UNITED STATES ENVIRONMENTAL PROTECTION AGENCY
REGION 10
1200 Sixth Avenue
Seattle, Washington 98101

Draft - Injection test

SUBJECT: DOCUMENT REVIEW: Injection Test Results -
Wells F-3, F-4 and F-4A

SUBJECT: OCC X-SECTIONS

INJECTION SYSTEM

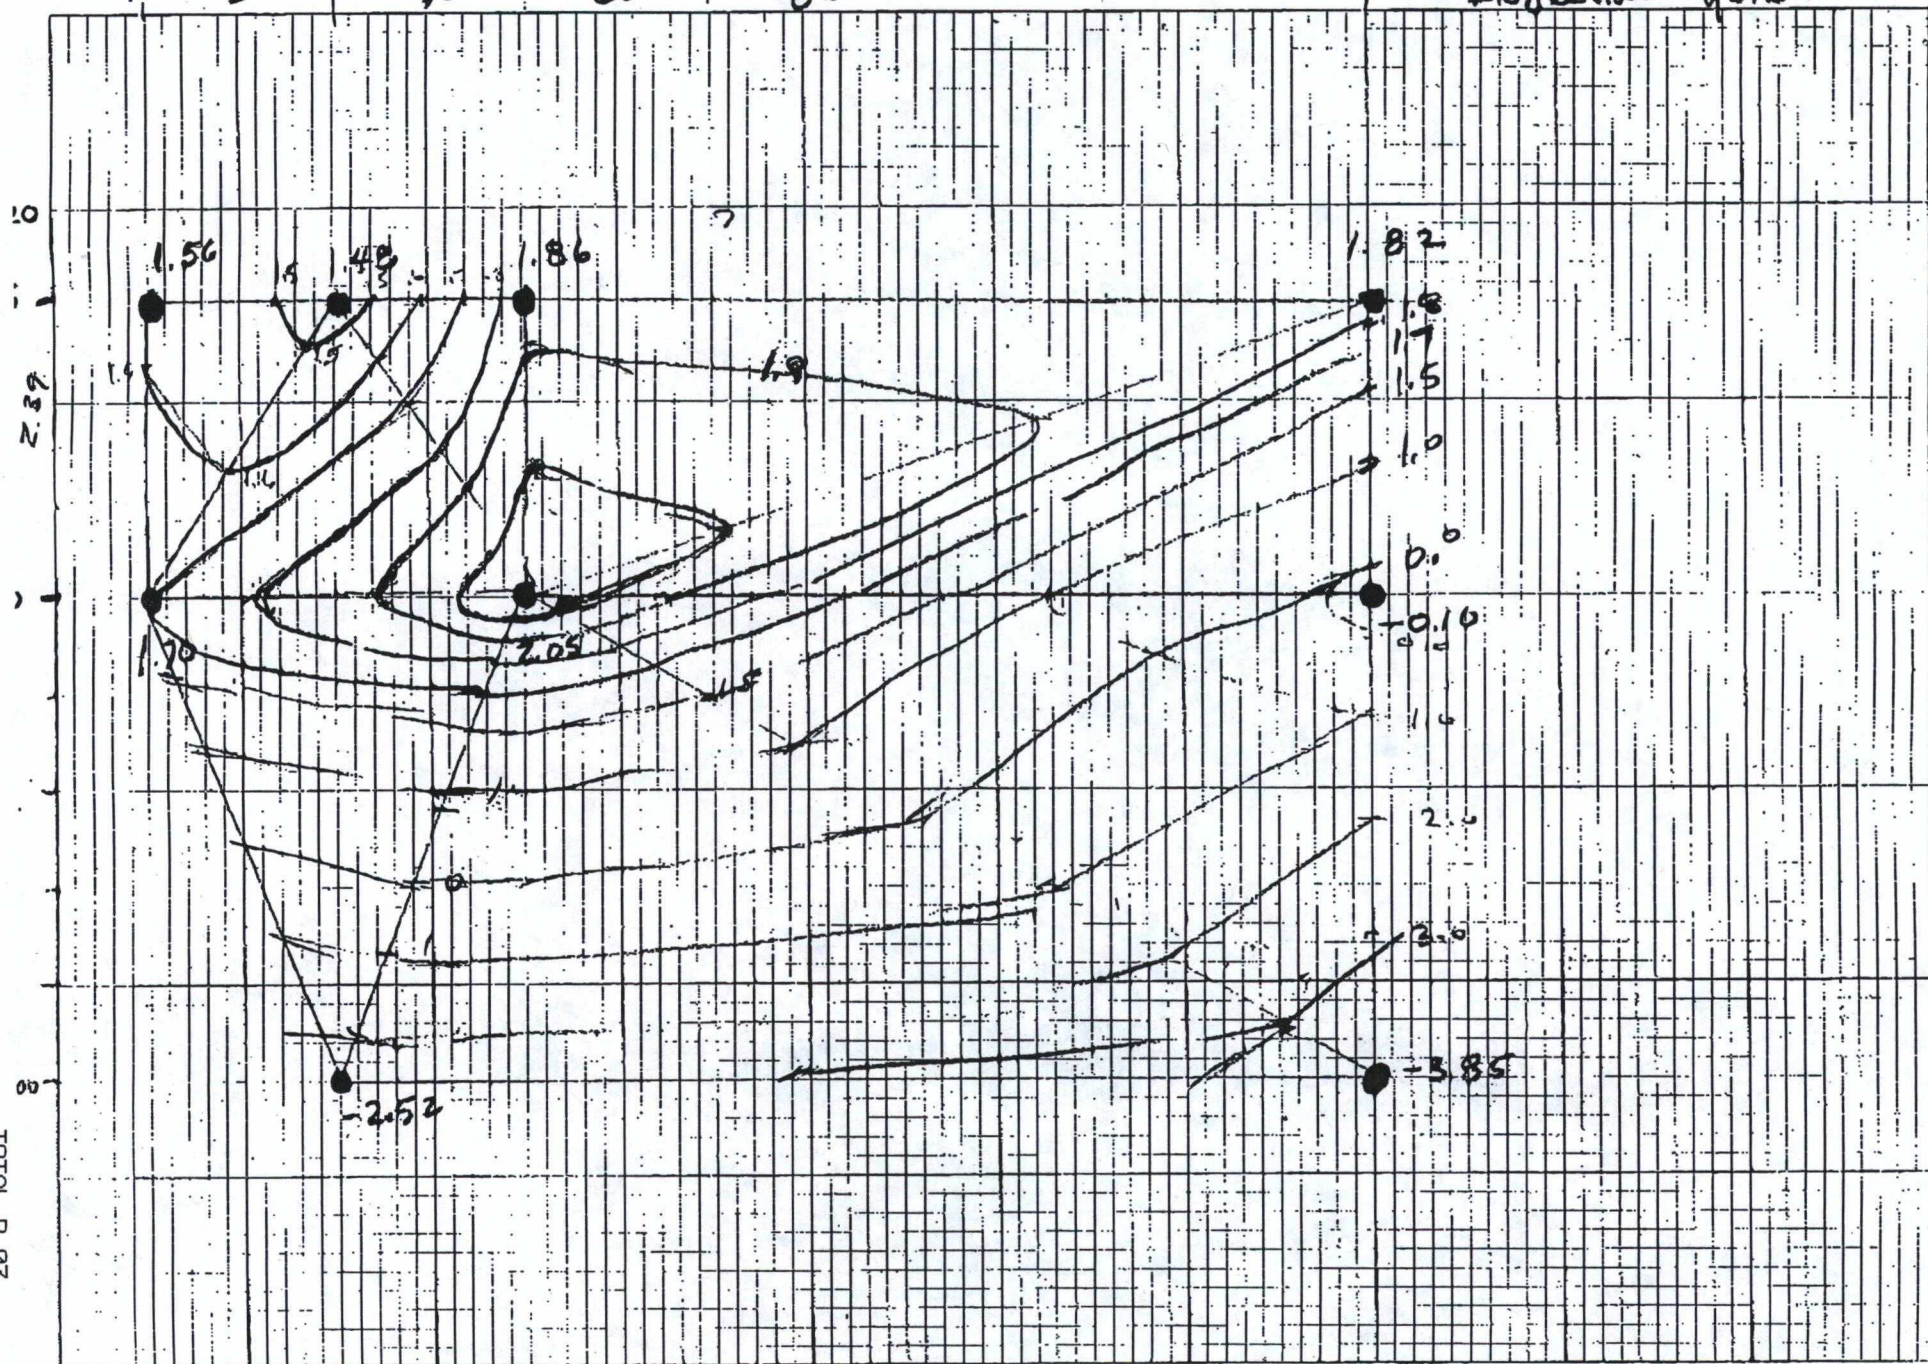
The attached X-sections are the types of products that should be present in OCC reports to demonstrate that the CAP is accomplishing the objectives of creating a mound that overlaps adjoining injection wells or ~~capture~~ capture zones that overlap adjoining extraction wells.
